Re: FortisBC Energy Inc. (FEI)
2022 Long Term Gas Resource Plan (LTGRP) – Project No. 1599324
Response to the B.C. Sustainable Energy Association (BCSEA) Information Request (IR) No. 1

FortisBC Energy Inc. (FEI or the Company) 2022 Long Term Gas Resource Plan (LTGRP) (Application)	Submission Date: December 22, 2022
Response to BC Sustainable Energy Association (BCSEA) Information Request (IR) No. 1	Page 2

Figure 9-3: BC and Global Emission Reductions (Life Cycle) in the Diversified Energy (Planning) Scenario from Serving the Transportation and Global LNG Markets

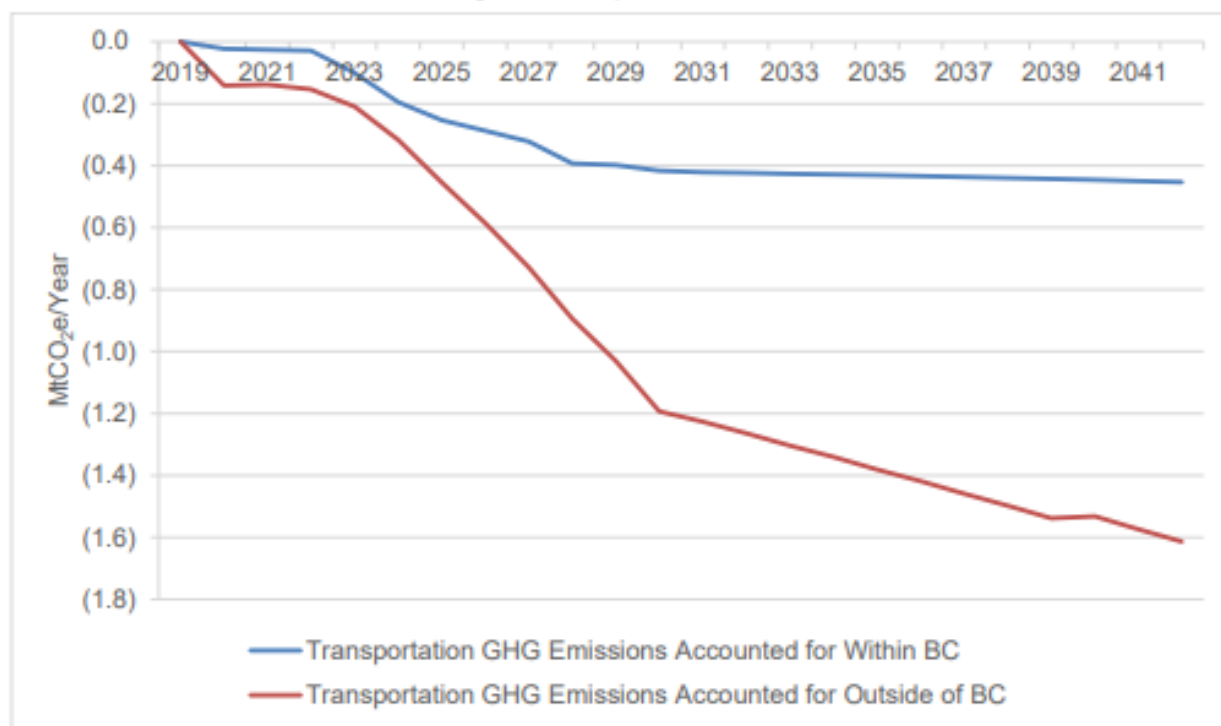
8.3 Given that FEI's customers will soon have to substantially reduce their collective GHG emissions from the combustion of gas from FEI due to the requirements of the GHG Reduction Standard as anticipated in the CleanBC Roadmap to 2030, would FEI's 2022 LTGRP be improved by increasing the focus on reductions of customers' GHG emissions and reducing the focus on GHG reductions in Marine Fueling and Global Markets?

19 The information requested is provided in Figure 9-3, Section 9.2.2 on page 9-6 of the Application,
20 and reproduced below. The emission reductions that are shown in the lower, red line in this figure,
21 and which are accounted for outside of BC, can be viewed as the reductions resulting from Pillar
22 4 of FEI's Clean Growth Pathway. This is a conservative estimate of the global emissions
23 reductions that can be achieved as part of Pillar 4 activities. The emissions shown by the upper
24 blue line, and indicated as occurring within BC, can be viewed as resulting from Pillar 3 activities.

Figure 1: Natural Gas Price Forecast and the Blended Cost of Gas for Natural and Renewable Gas (Includes Carbon Tax)

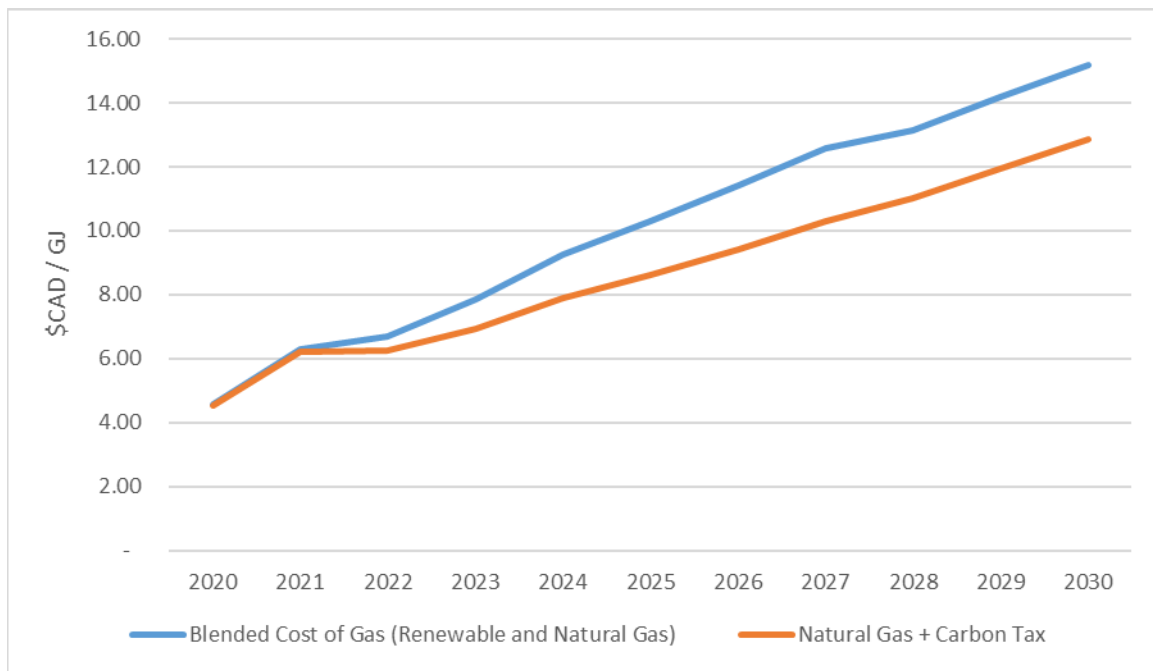
18.1 Please provide versions of Figures 2 and 3 with superimposed curves of: the conventional natural gas price forecast that FEI uses, and a curve of the price for a blended conventional gas and RG commodity that FEI believes it could realistically charge its customers while achieving the decarbonization of FEI's gas system needed to achieve the goals of the Roadmap to 2030.

FEI is unable to alter Figures 2 and 3 from British Columbia Renewable and Low-Carbon Gas Supply Potential Study¹² as requested. However, FEI has provided a figure below showing the conventional natural gas price forecast (including the carbon tax) and a blended (or weighted average) cost of gas for conventional natural gas and renewable gas price out to 2030. The conventional natural gas and the renewable gas prices were used in modeling individual scenarios; however the blended cost was only used in Section 9 of the Application where FEI calculated cumulative rate (bill) impacts for residential (RS 1) customers under the DEP Scenario.

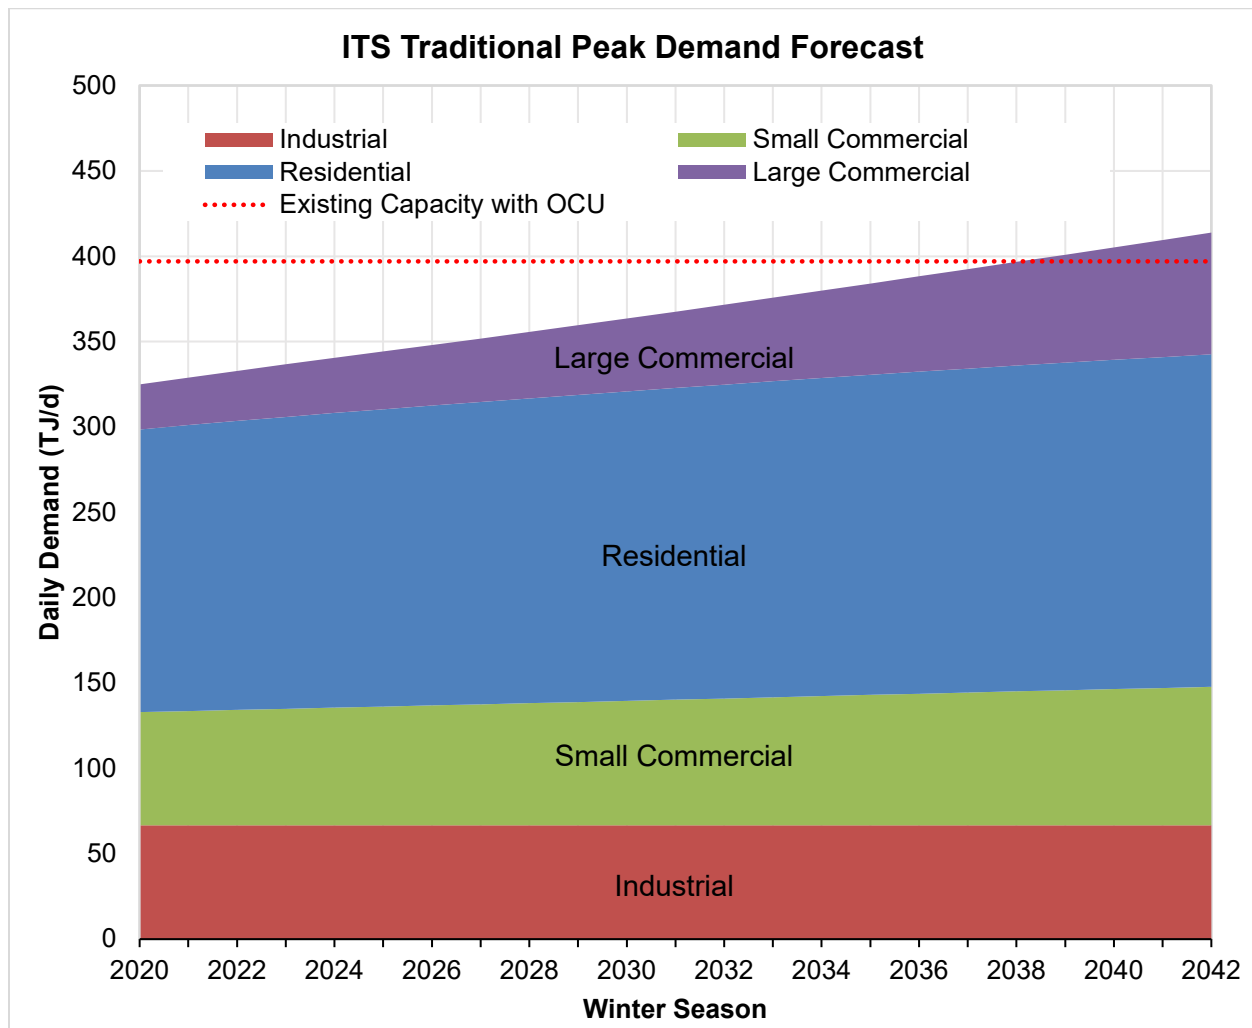
4
5
6
7
8 21.11 Figure 7-14: ITS Traditional Peak Demand Forecast makes it look (superficially)
9 like growth in Residential peak load causes the capacity gap emerging in 2038.
10 Please provide a version of Figure 7-14 with Industrial, Small Commercial,
11 Residential, and Large Commercial from the bottom to the top.
12

14 The requested revised figure is provided below. The peak demand on the system is the
15 summation of the peak demand contribution from all customers on the system. BCSEA is correct
16 that it would be a superficial assessment to attribute responsibility for the system peak demand
17 exceeding capacity to any one customer group simply according to the way they are stacked in
18 the graphical representation.

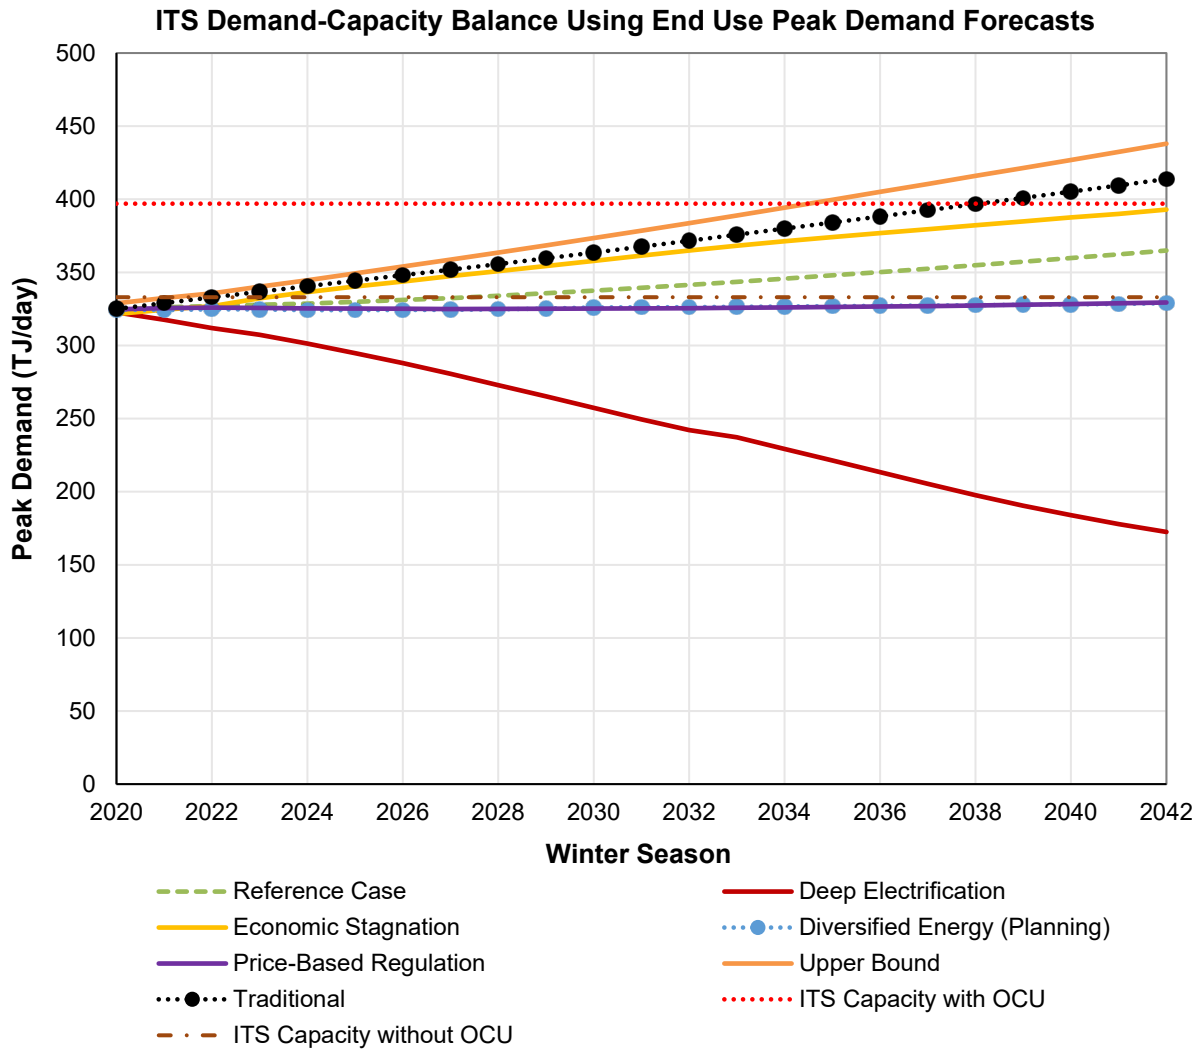
21.12 Figure 7-15: ITS Demand-Capacity Balance Using End Use Peak Demand Forecasts shows Existing Capacity with OCU as a dotted red line. Please provide a version of Figure 7-15 showing Existing Capacity without OCU, as well as Existing Capacity with OCU.

2 The requested revised figure is provided below showing ITS capacity before and after the OCU
3 Project.

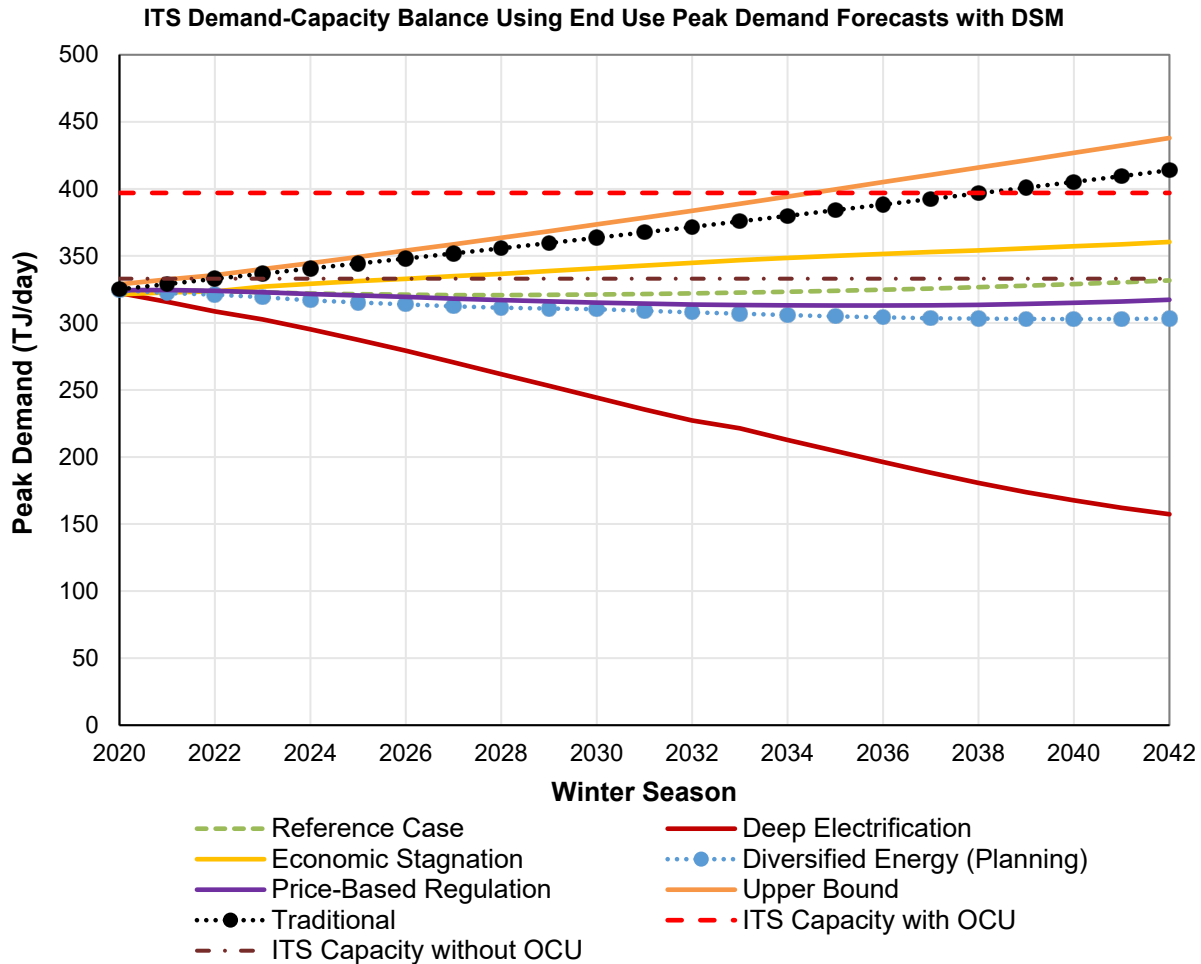
21.13 Figure 7-16: ITS Demand-Capacity Balance Using End Use Peak Demand Forecasts with DSM shows Existing Capacity with OCU as a dotted red line. Please provide a version of Figure 7-16 showing Existing Capacity without OCU, as well as Existing Capacity with OCU.

2 The requested revised figure is provided below showing ITS capacity before and after the OCU
3 Project.

Updated Figure 9-7: Cumulative Effective Rate Impact (2022 – 2042) – Residential RS 1, Avg. UPC 60 GJ

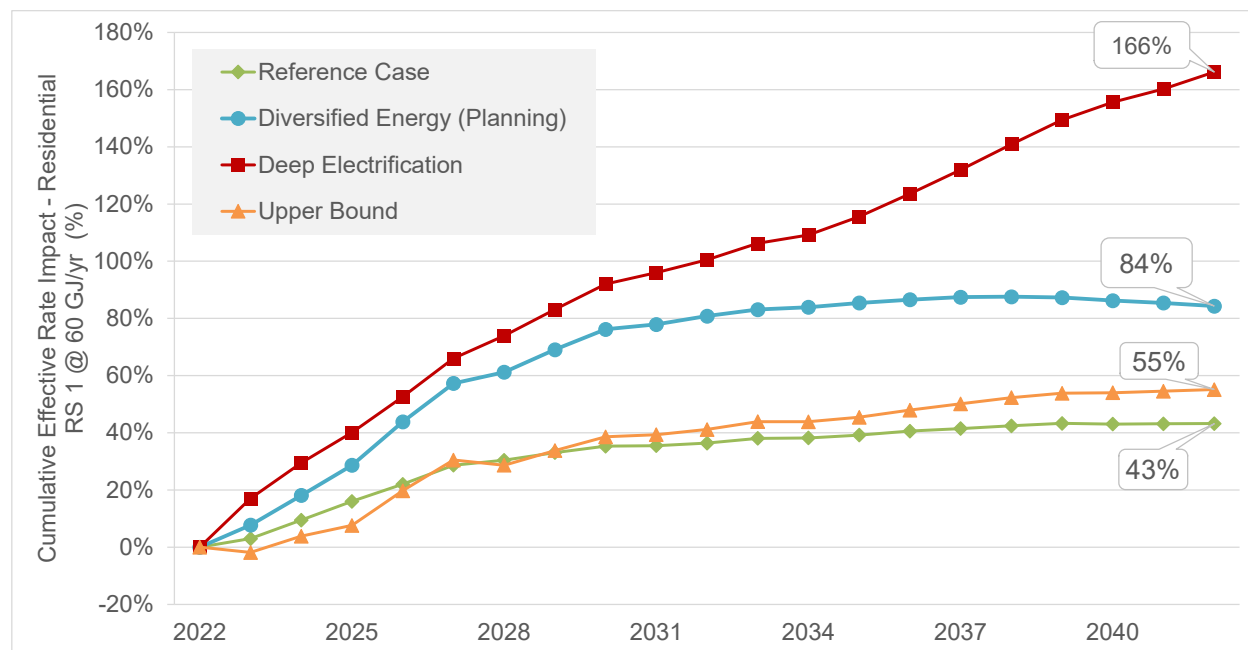
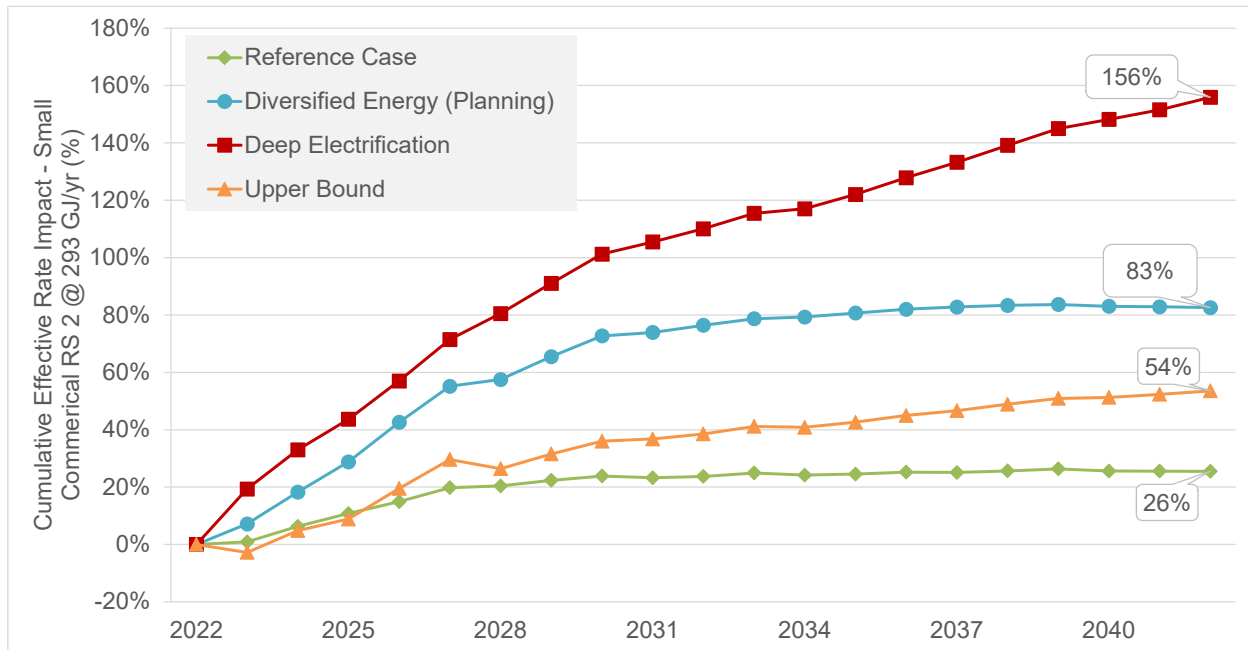
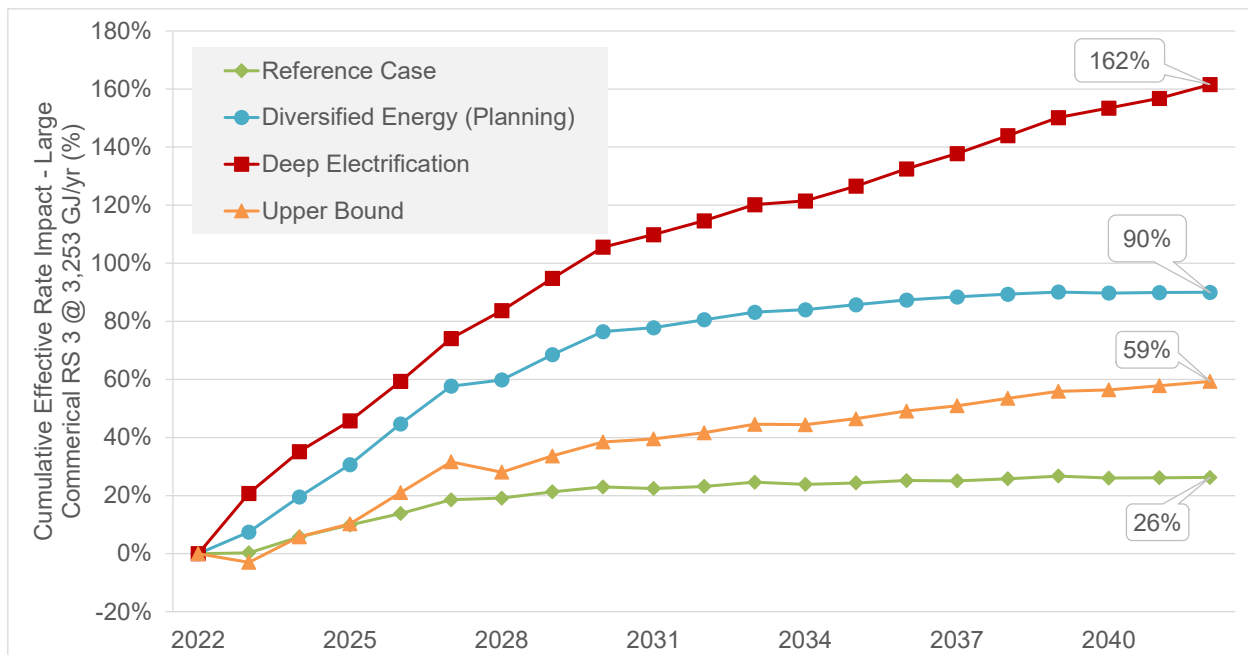
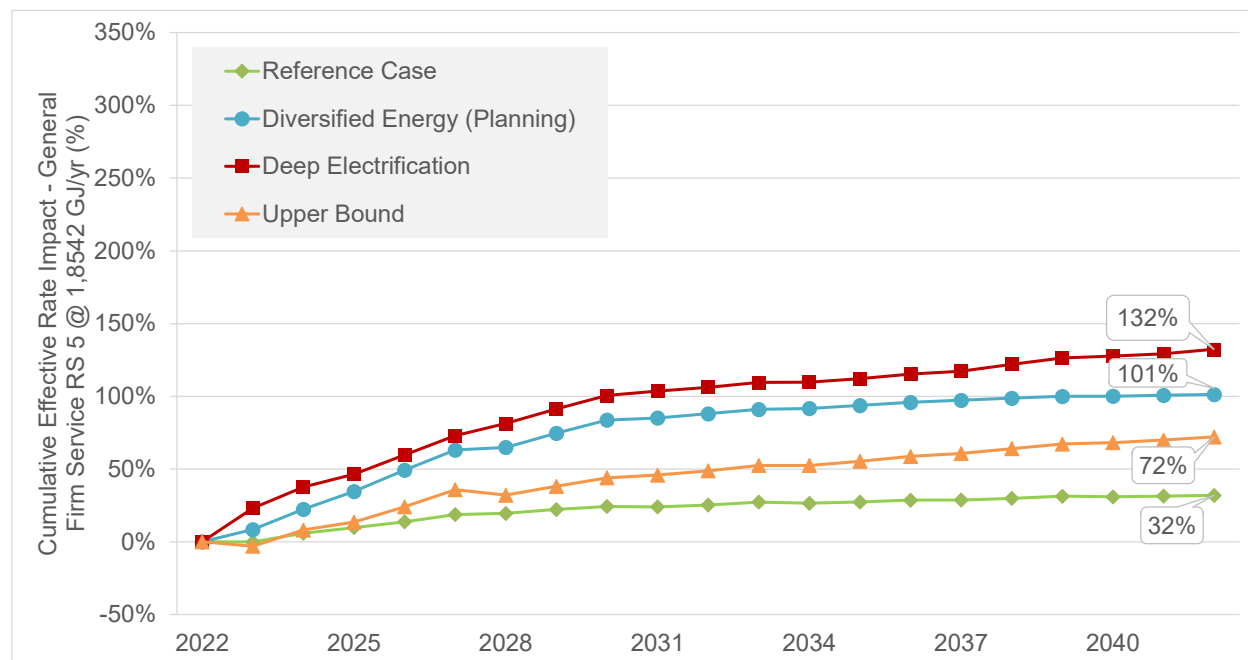
30.7 For Figures 9-7 through 9-10 and Table 9-2, are the effects of inflation removed? If not, please provide versions of the figures and table with inflation removed.

Figures 9-7 through 9-10 and Table 9-2 do include inflation. Please see the below updated figures and table with inflation removed.

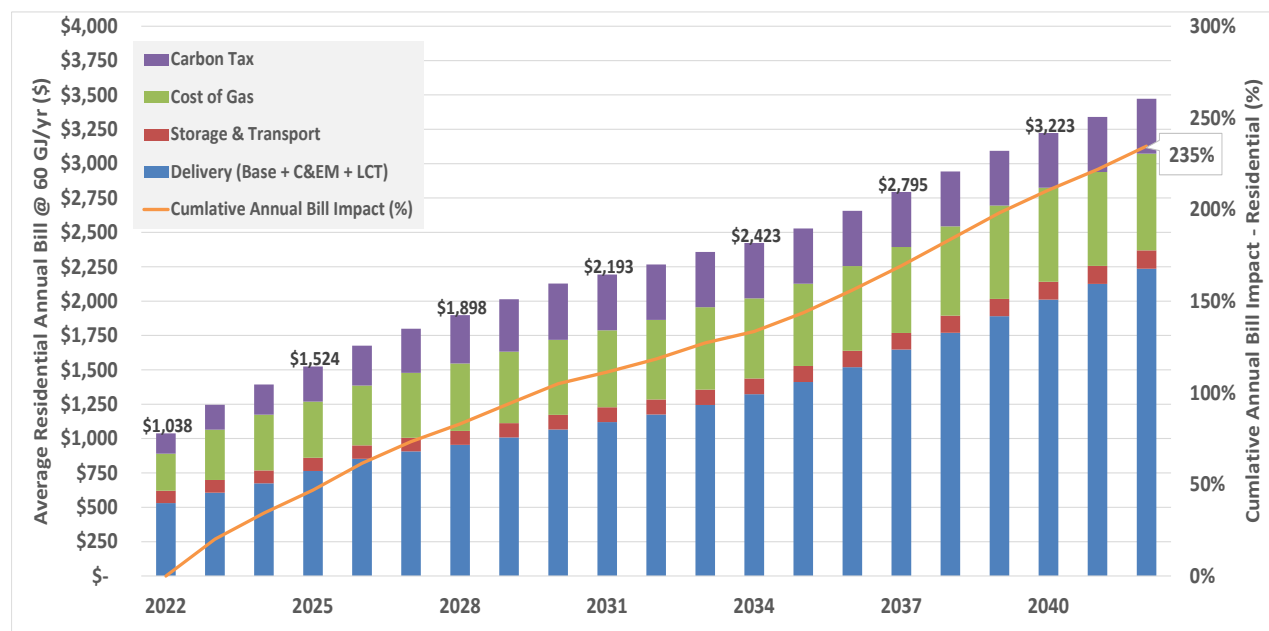
30.8 If possible, please provide a breakdown of the item “Delivery (Base + C&EM + LCT)” shown in Figure 9-11.

Please refer to the response to BCOAPO IR1 9.7.
